Email: caas_singaporeais@caas.gov.sgURL: www.caas.gov.sgURL: <https://aim-sg.caas.gov.sg>**AIP Supplement for
Singapore****AIP SUP****100/2020****Effective from 18 NOV 2020****/ 12 MAY 2021****Published on 13 OCT 2020**

SINGAPORE CHANGI AIRPORT – PARTIAL CLOSURE OF TAXILANE R1 AND TEMPORARY REVISION/REMOVAL OF GROUND MARKINGS AT TAXILANE R1 AT TERMINAL 2

ENLARGED LOCATION PLAN SHOWING CLOSED AREA ON TAXILANE R1 AND CHANGES TO GROUND MARKINGS TILL 12 MAY 2021 2200UTC

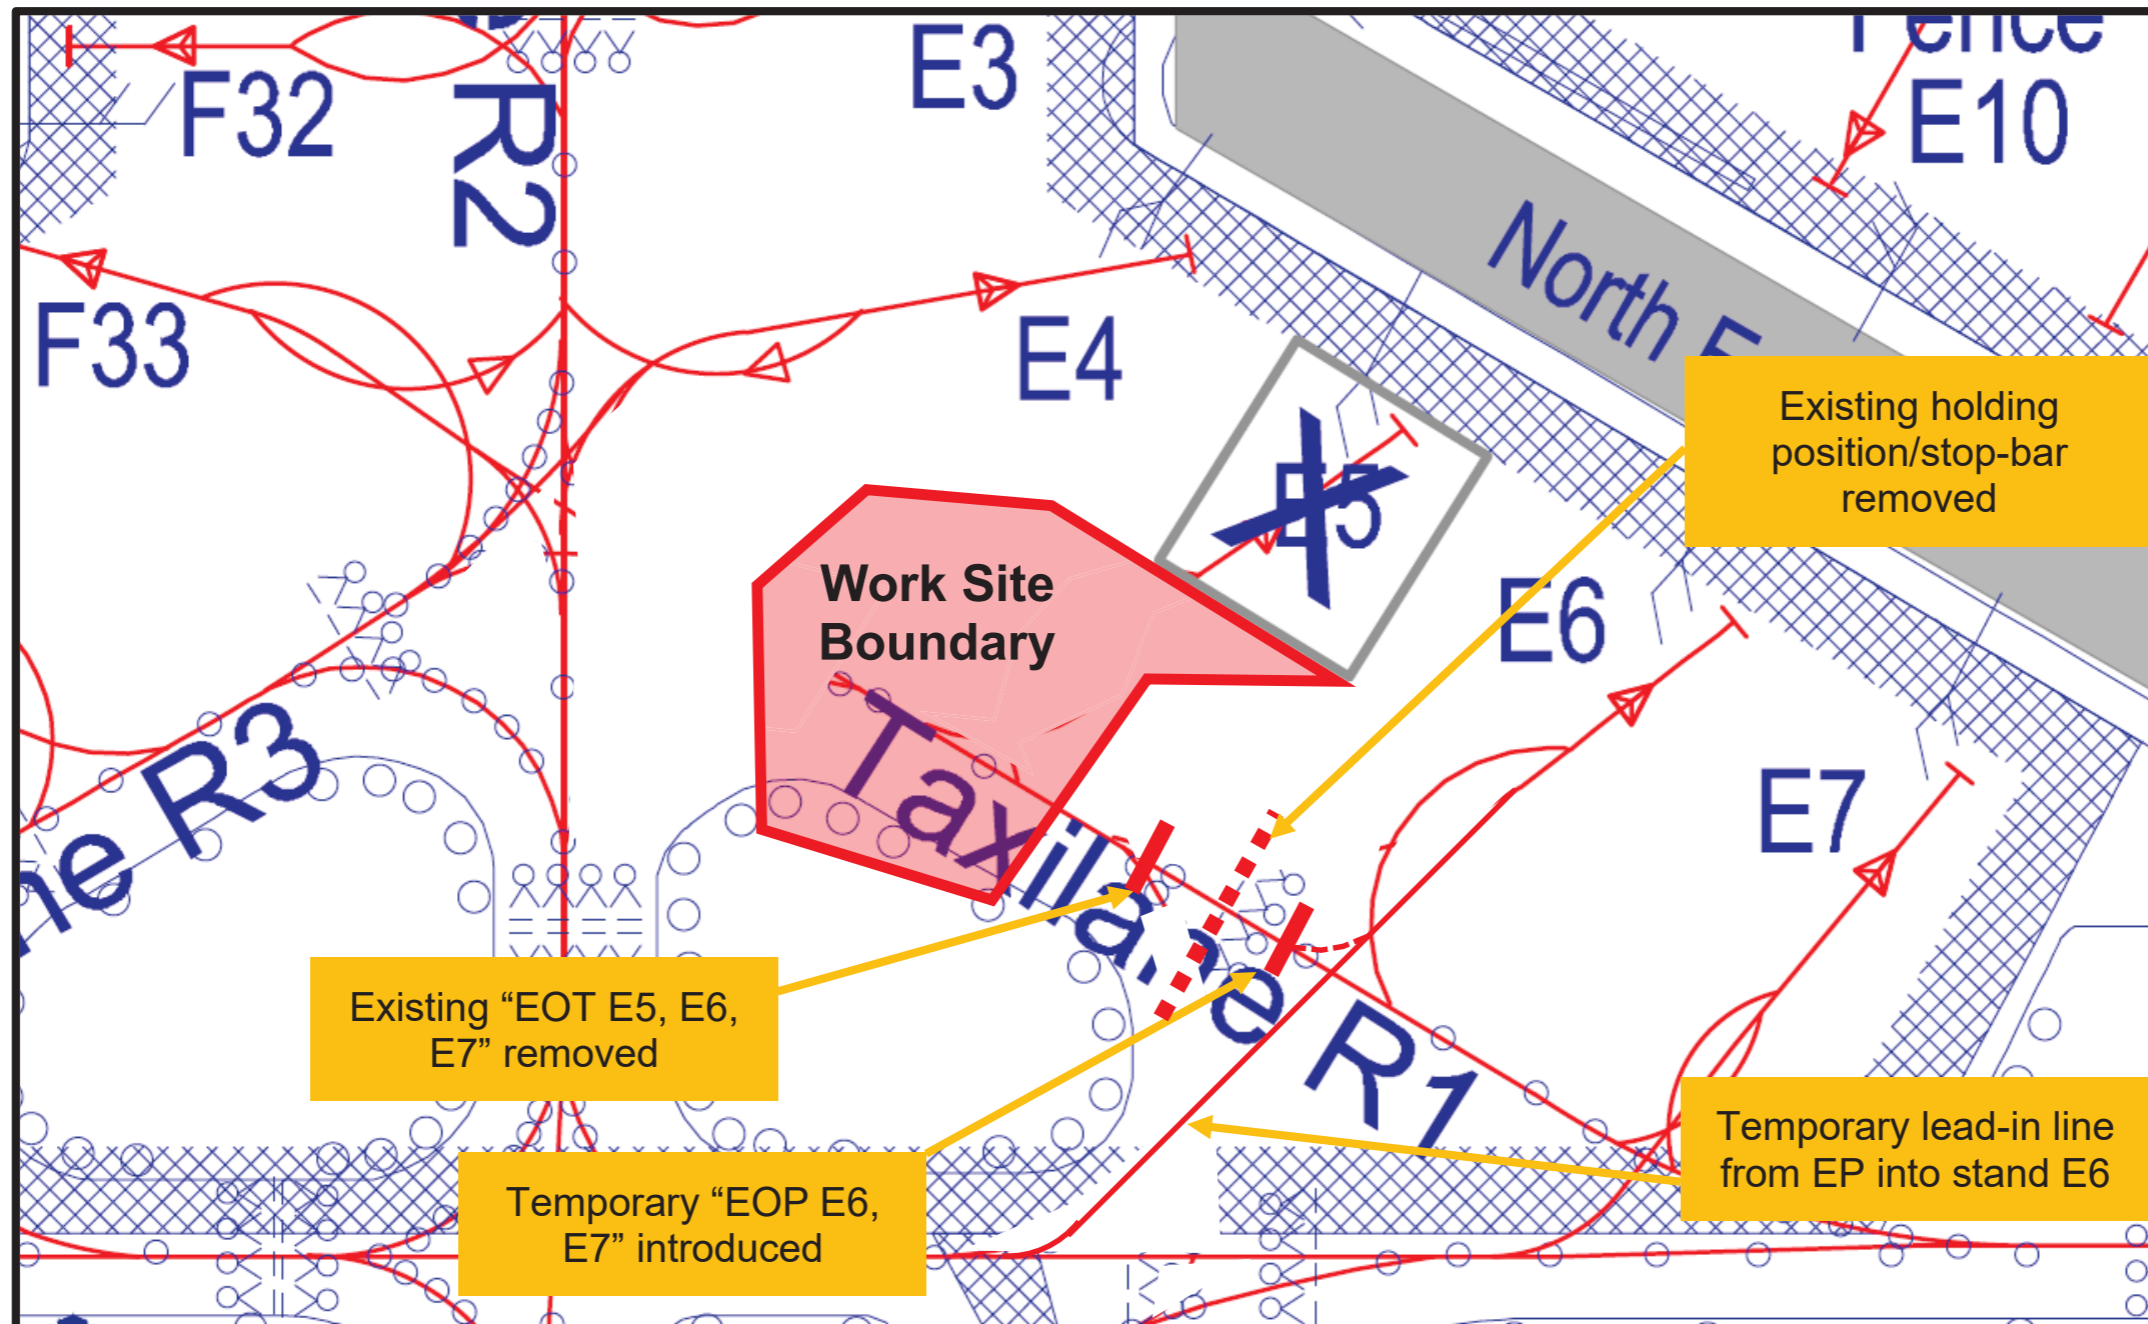
2.2 Taxilane R1 has been closed for construction works since 27 September 2020. With partial completion of the construction works, Taxilane R1 behind aircraft stands E6 and E7 will re- open while the part of Taxilane R1 behind aircraft stand E5 remains closed until 12 May 2021 2200 UTC. The closed area is as shown in **Appendix B**.

- a. The lead-in line marking for aircraft stand E6 will be revised;
- b. The existing intermediate holding position on Taxilane R1 (hold short of Taxiway EP) will be removed and the stopbar lights will not be in use;
- c. The existing End-of-Tow E5, E6, E7 on Taxilane R1 will be removed and replaced with an End-of-Push E6, E7;
- d. Taxiway centreline and lights on Taxiway EP (towards North), turning West into Taxilane R1 and vice versa will be unavailable; and
- e. Taxiway centreline and lights on Taxiway E4 exiting Runway 02C leading into Taxilane R1 will be unavailable.
